**DOCUMENT 00 90 00  
ADDENDUM**

**ADDENDUM NO. [2]                      Date: January 5, 2022**

**RE:                      SCHOOL DISTRICT OF ABBOTSFORD  
ABBOTSFORD SCHOOL DISTRICT FEMA ADDITION  
510 WEST HEMLOCK STREET  
ABBOTSFORD, WISCONSIN 54405  
HSR PROJECT NO. 21027**

**A300**

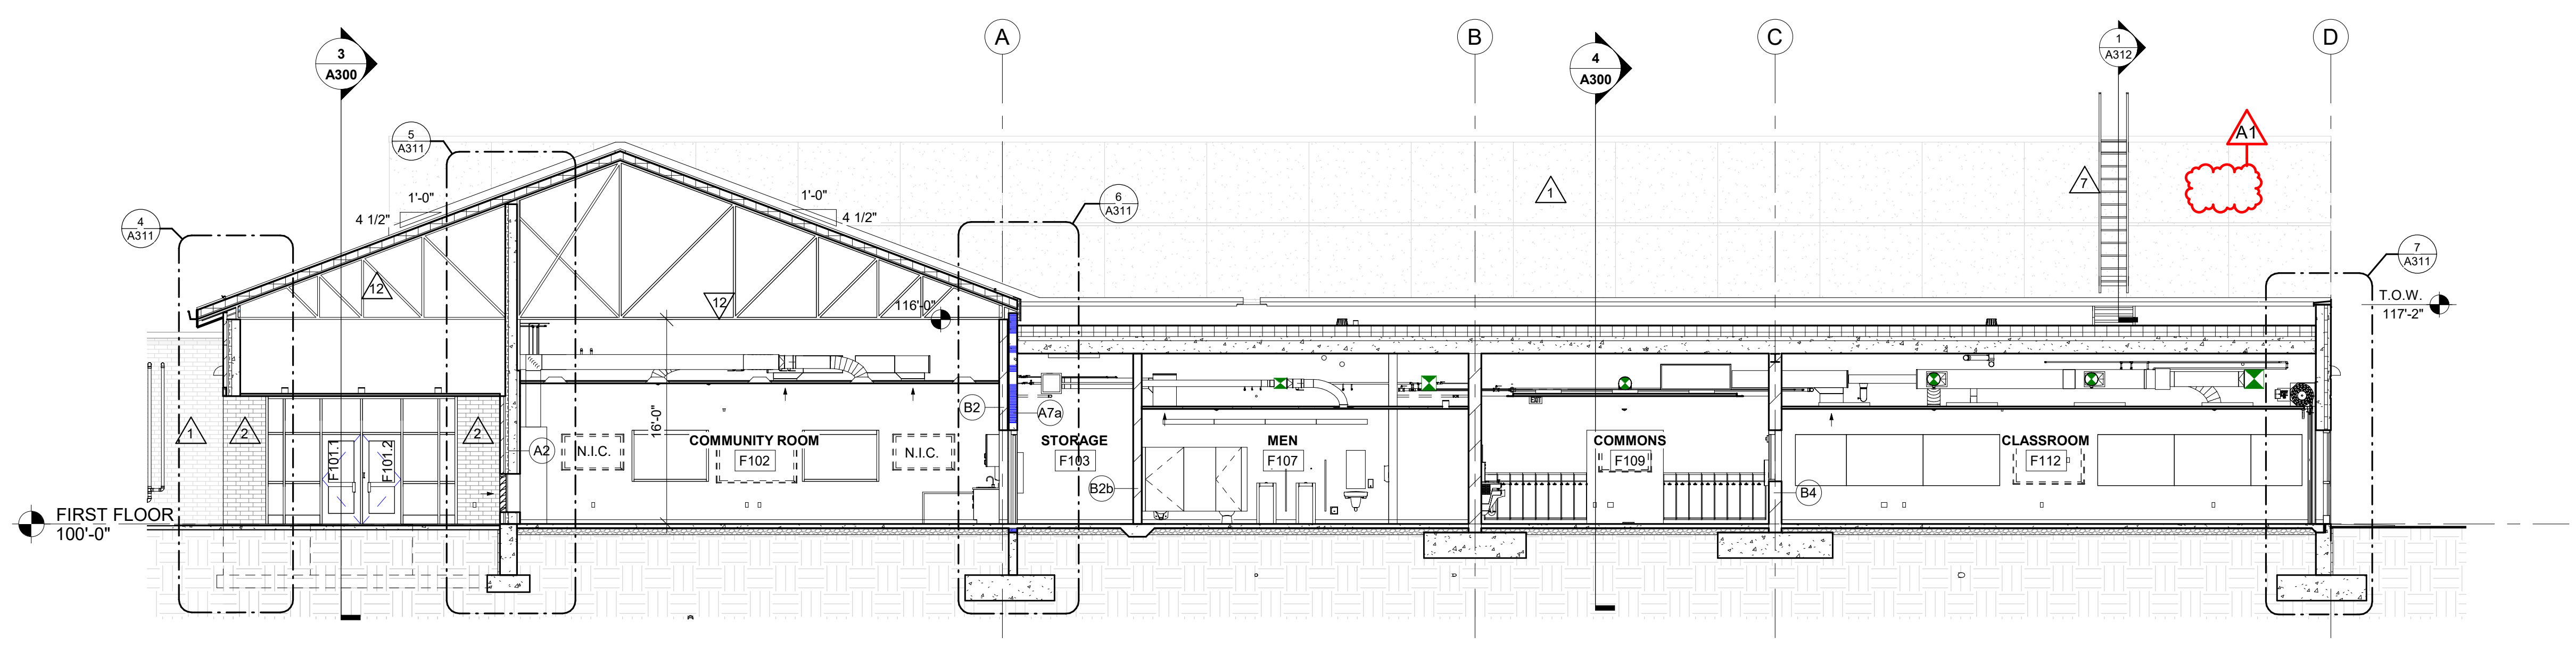
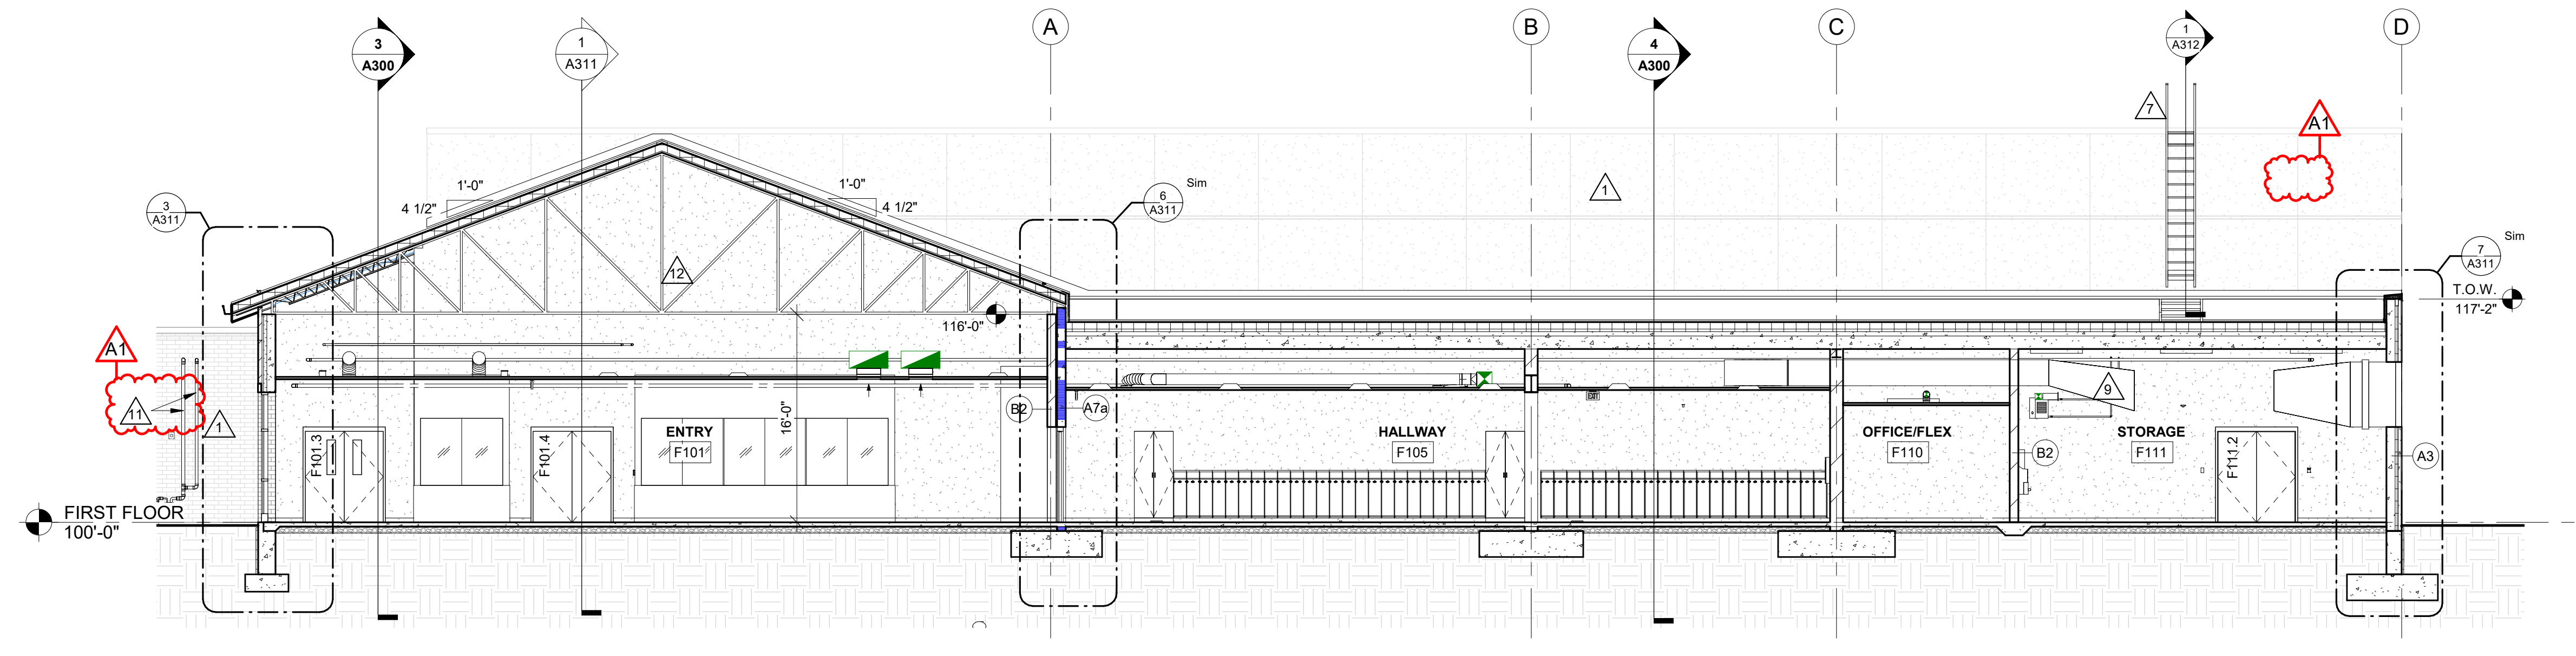
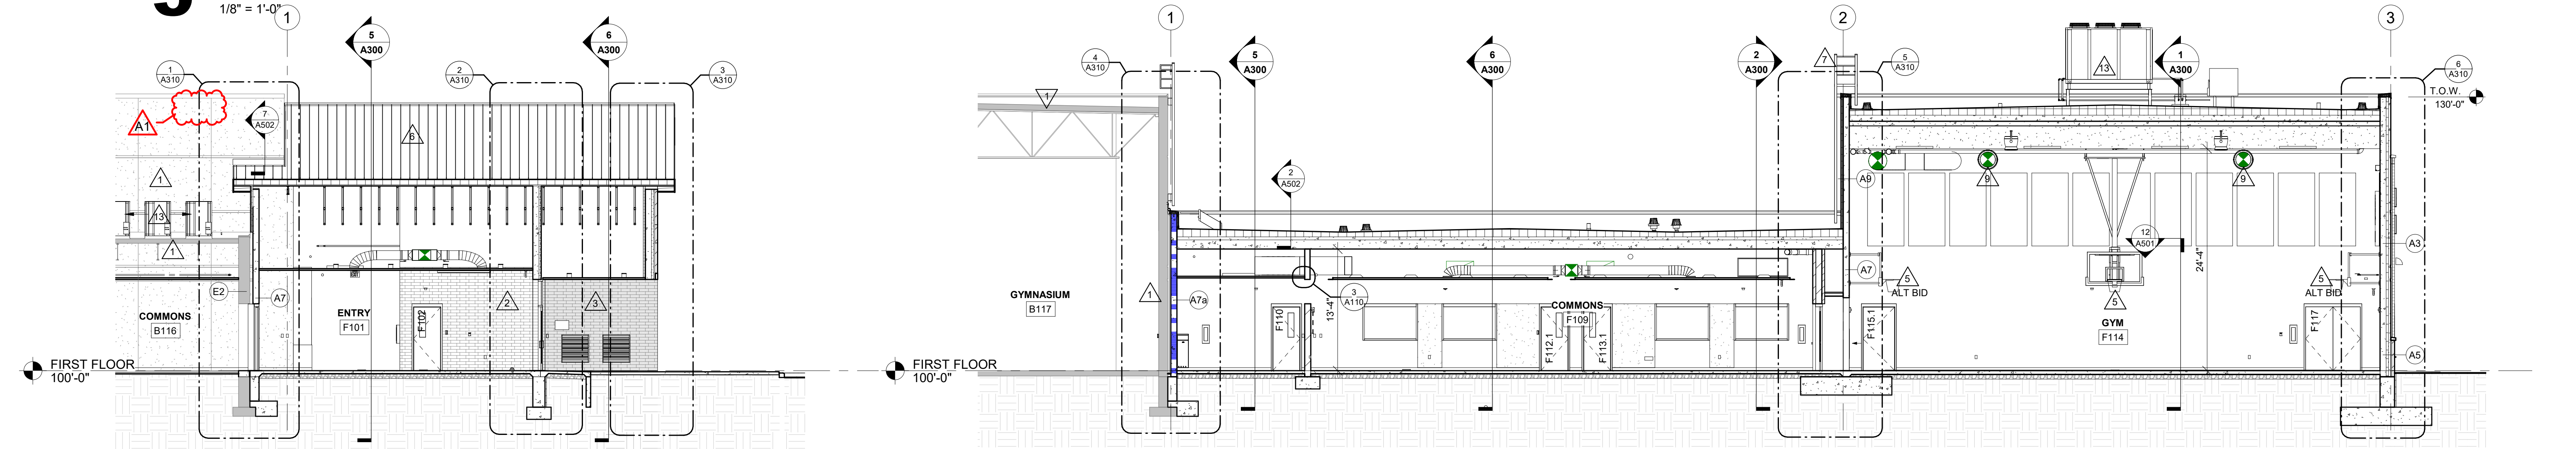
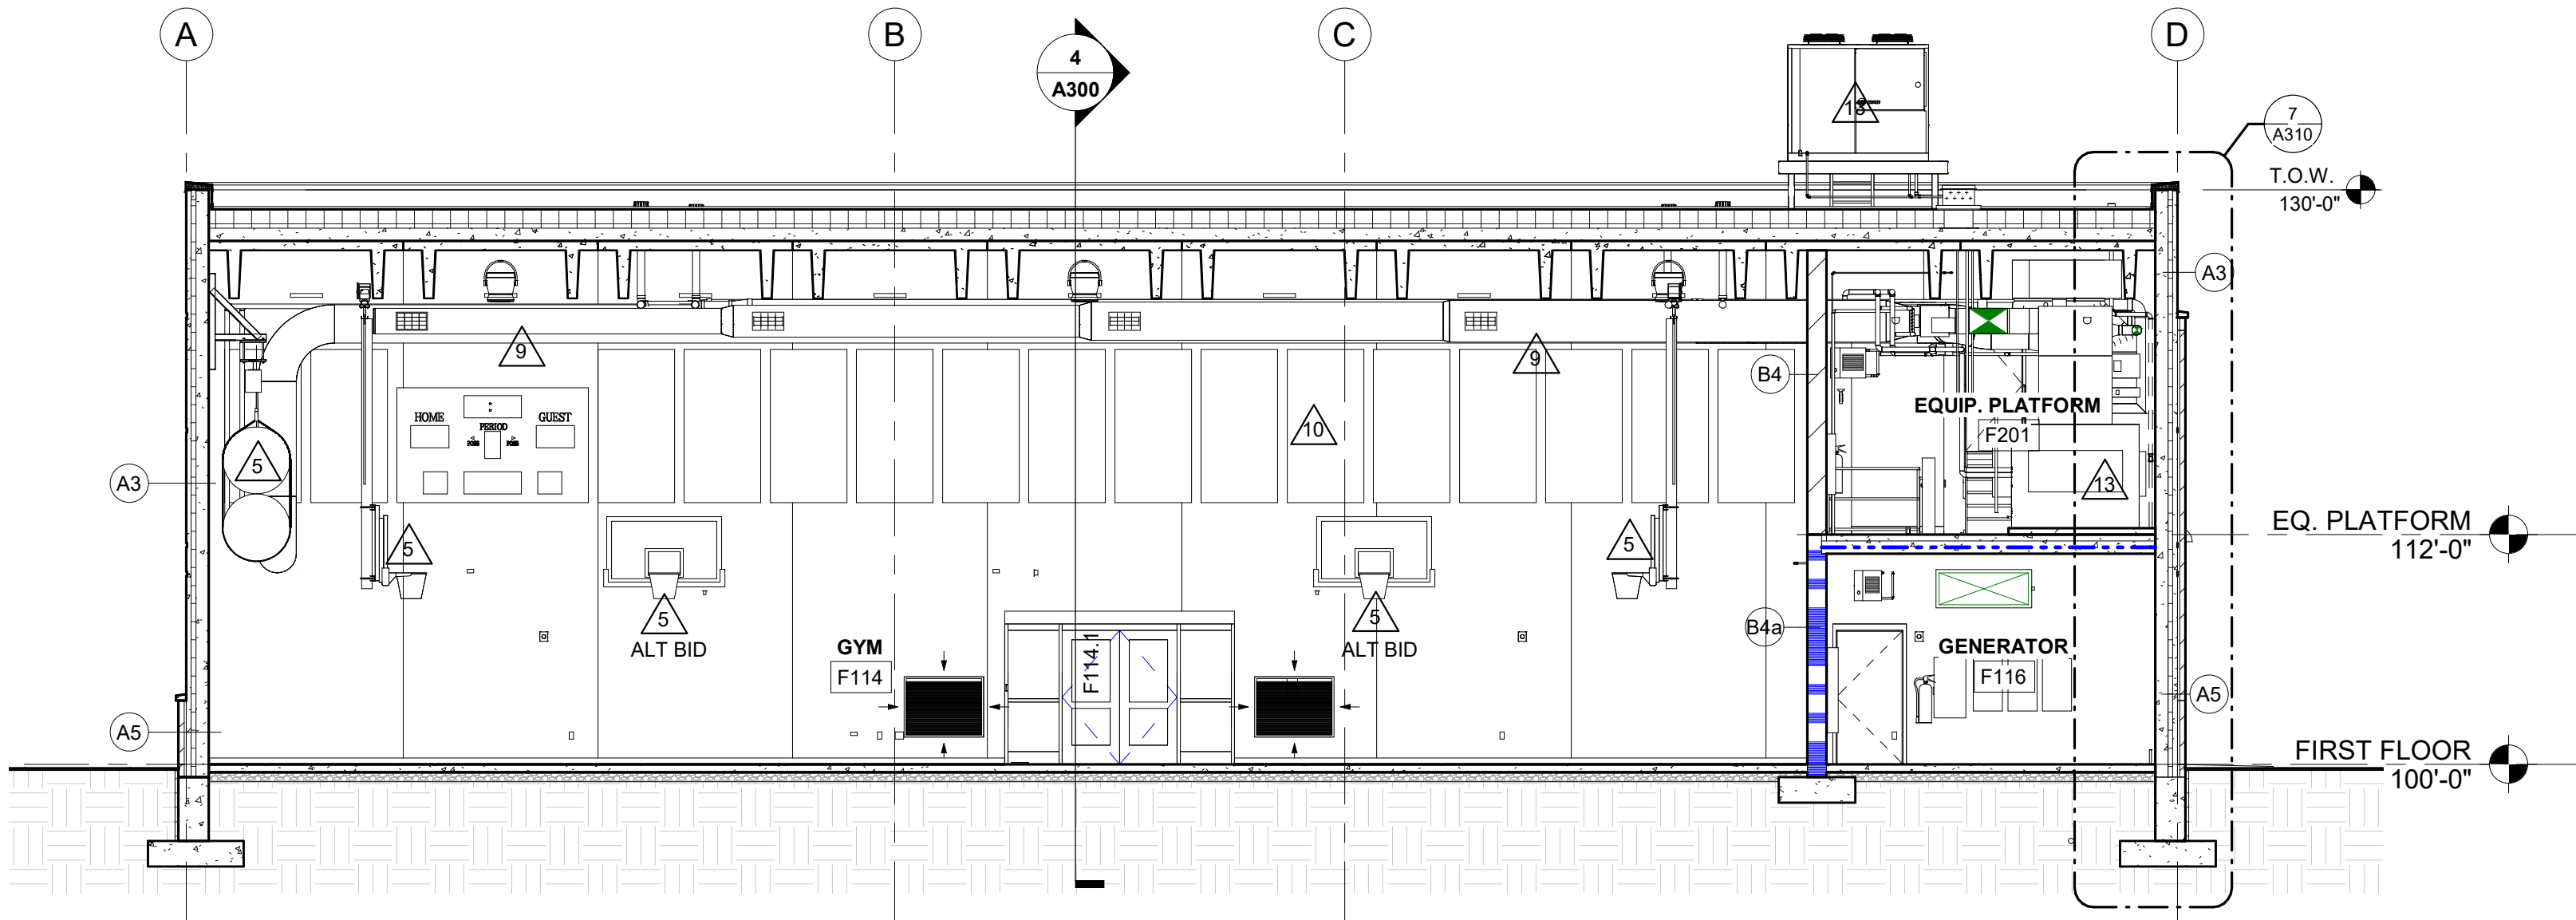
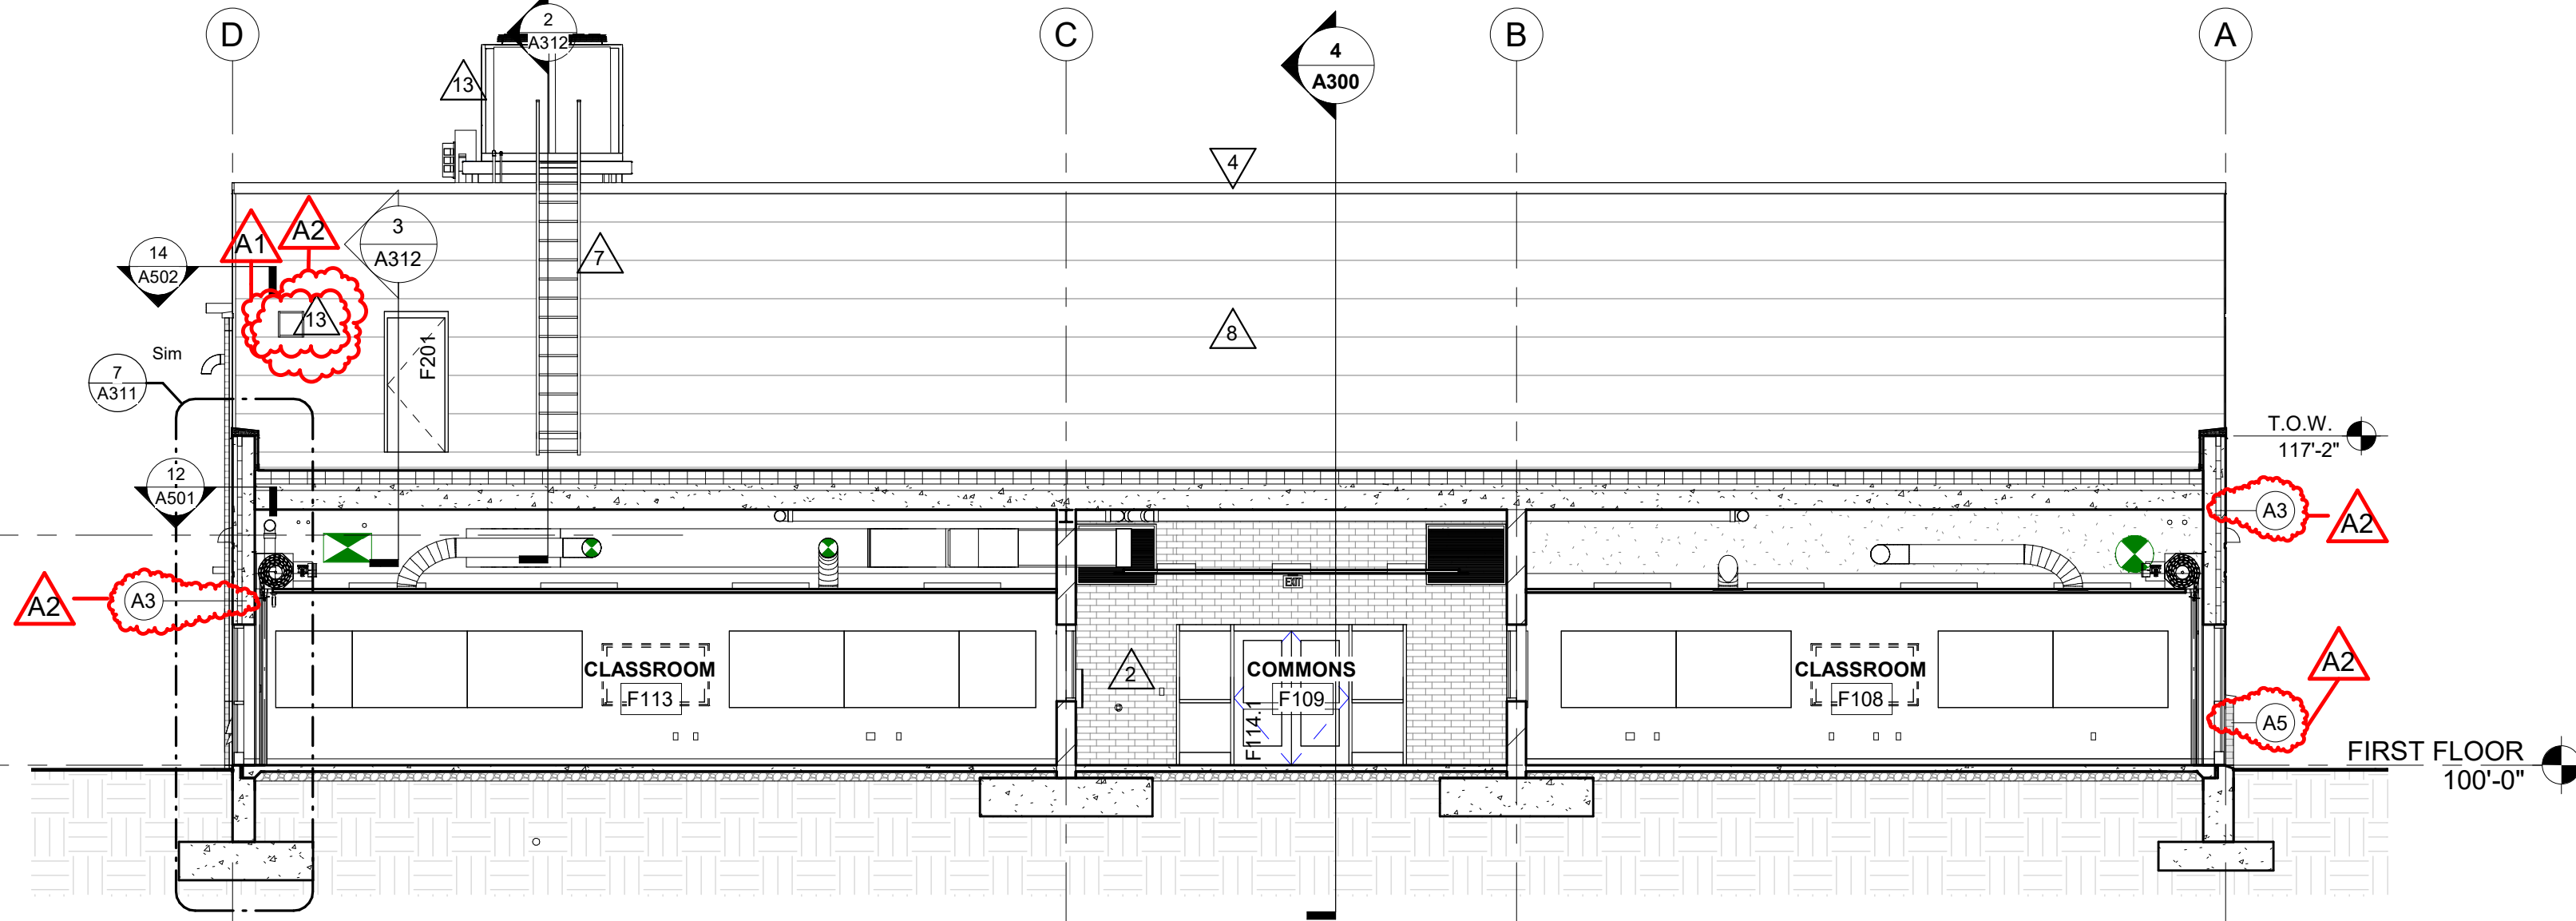
16. Sheet A300 SECTIONS revised 30 x 42 sheet attached hereto.

- a. Relocated mechanical equipment at the roof.
- b. Added wall type callouts in building section #2.
